Subject: Saxton Nuclear Experimental Corporation
Operating License No. DPR-4
Docket No. 50-146
Response to Request for Additional Information Regarding
Technical Specification Change Request 54 and Resultant
Supplement

Operating License No. DPR-4
Docket No. 50-146
Response to Request for Additional information:
Technical Specification Change Request No. 54

Figure 1

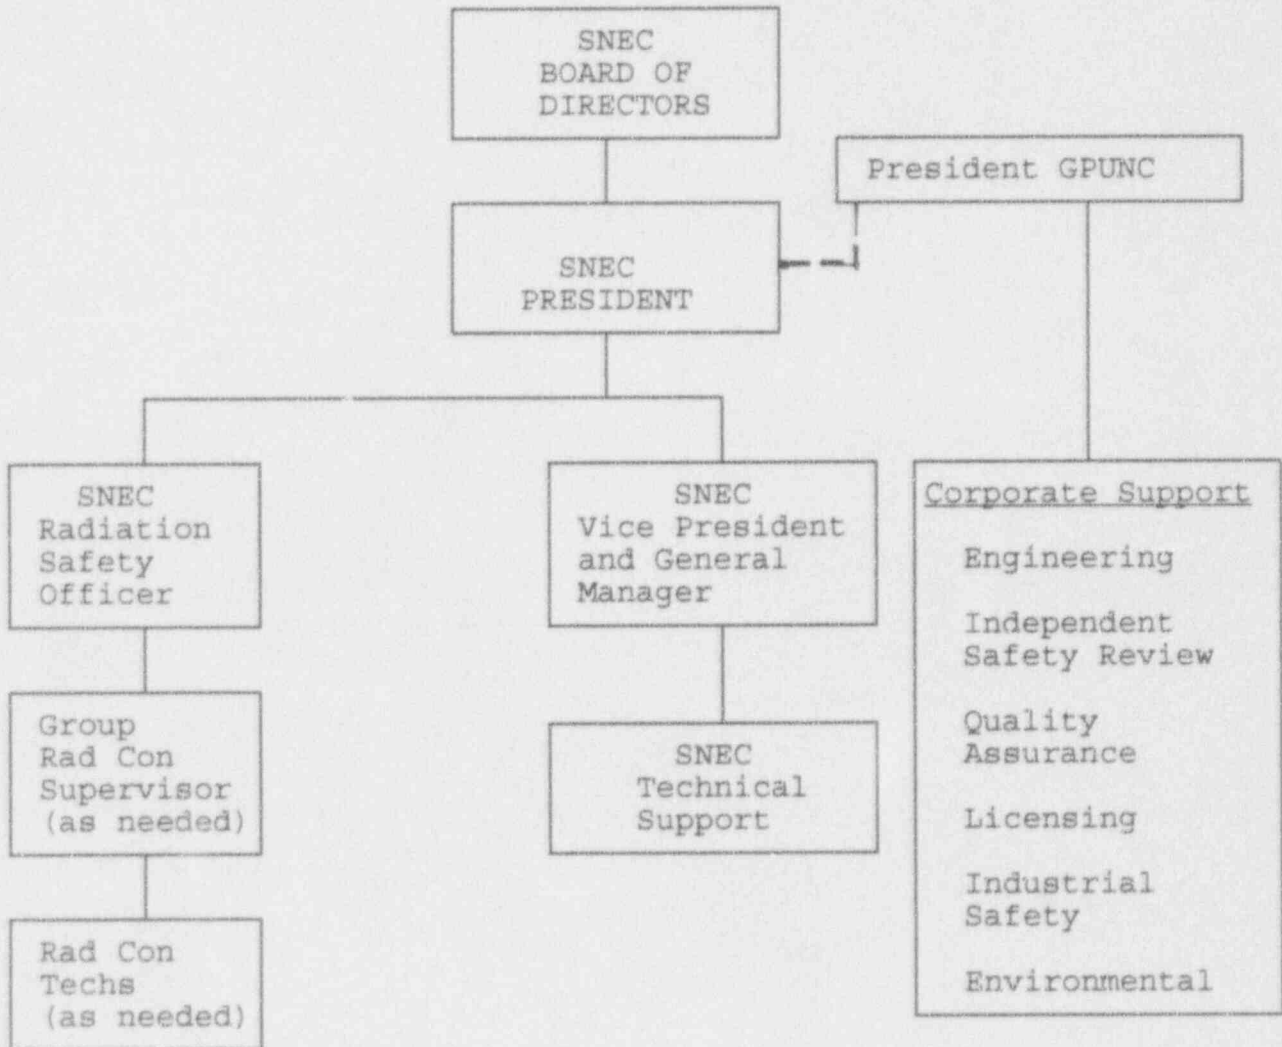
Question 1 Administrative Organization

The SNEC Board of Directors elects a President and Vice President from GPUNC to carry out the responsibilities of the Corporation. Technical support functions such as quality assurance, radiation protection, and independent safety review are also provided by GPUNC. The SNEC organization is shown in the included figure.

The radiation protection function is the responsibility of the Radiation Safety Officer or RSO. This position is independent of all other organizational responsibilities and reports directly to the SNEC President.

The audit function is provided through GPUNC. The audit functions are conducted independently of SNEC line management responsibilities.

Independent review for SNEC is provided as described in the response to question 4. This group reports directly to the President - GPUNC.
